## Product Change Notice (PCN)

PCN Number: PCN-0450005R-01

Product(s) Affected: MJ-3536N

PREVIOUS CUI DEVICES DETAIL / IMAGE	NEW CUI DEVICES DETAIL / IMAGE

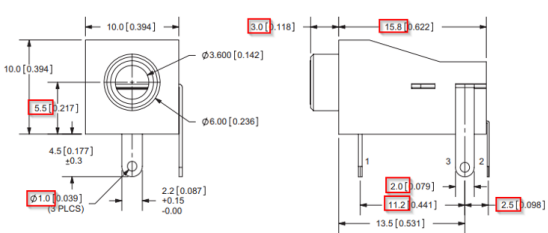
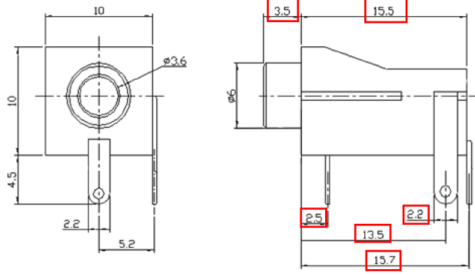
Description of Change: mechanical and material differences as shown below:

<p style="text-align: center;">PCB LAYOUT TOP VIEW</p>	 <p style="text-align: center;">Recommended PCB Layout Top View</p>																																				
<table border="1"> <thead> <tr> <th></th> <th>MATERIAL</th> <th>PLATING</th> </tr> </thead> <tbody> <tr> <td>terminal 1</td> <td>brass</td> <td>tin</td> </tr> <tr> <td>terminal 2</td> <td>copper alloy</td> <td>tin</td> </tr> <tr> <td>terminal 3</td> <td>brass</td> <td>tin</td> </tr> <tr> <td>bushing</td> <td>brass</td> <td>nickel</td> </tr> <tr> <td>plastic</td> <td>PBT</td> <td></td> </tr> </tbody> </table>		MATERIAL	PLATING	terminal 1	brass	tin	terminal 2	copper alloy	tin	terminal 3	brass	tin	bushing	brass	nickel	plastic	PBT		<table border="1"> <thead> <tr> <th>DESCRIPTION</th> <th>MATERIAL</th> <th>PLATING/COLOR</th> </tr> </thead> <tbody> <tr> <td>terminal 1</td> <td>brass</td> <td>silver</td> </tr> <tr> <td>terminal 2</td> <td>brass</td> <td>silver</td> </tr> <tr> <td>terminal 3</td> <td>brass</td> <td>silver</td> </tr> <tr> <td>bushing</td> <td>brass</td> <td>tin</td> </tr> <tr> <td>housing</td> <td>PA (LULB4V-0)</td> <td>black</td> </tr> </tbody> </table>	DESCRIPTION	MATERIAL	PLATING/COLOR	terminal 1	brass	silver	terminal 2	brass	silver	terminal 3	brass	silver	bushing	brass	tin	housing	PA (LULB4V-0)	black

MATERIAL	PLATING																																			
terminal 1	brass	tin																																			
terminal 2	copper alloy	tin																																			
terminal 3	brass	tin																																			
bushing	brass	nickel																																			
plastic	PBT																																				
DESCRIPTION	MATERIAL	PLATING/COLOR																																			
terminal 1	brass	silver																																			
terminal 2	brass	silver																																			
terminal 3	brass	silver																																			
bushing	brass	tin																																			
housing	PA (LULB4V-0)	black
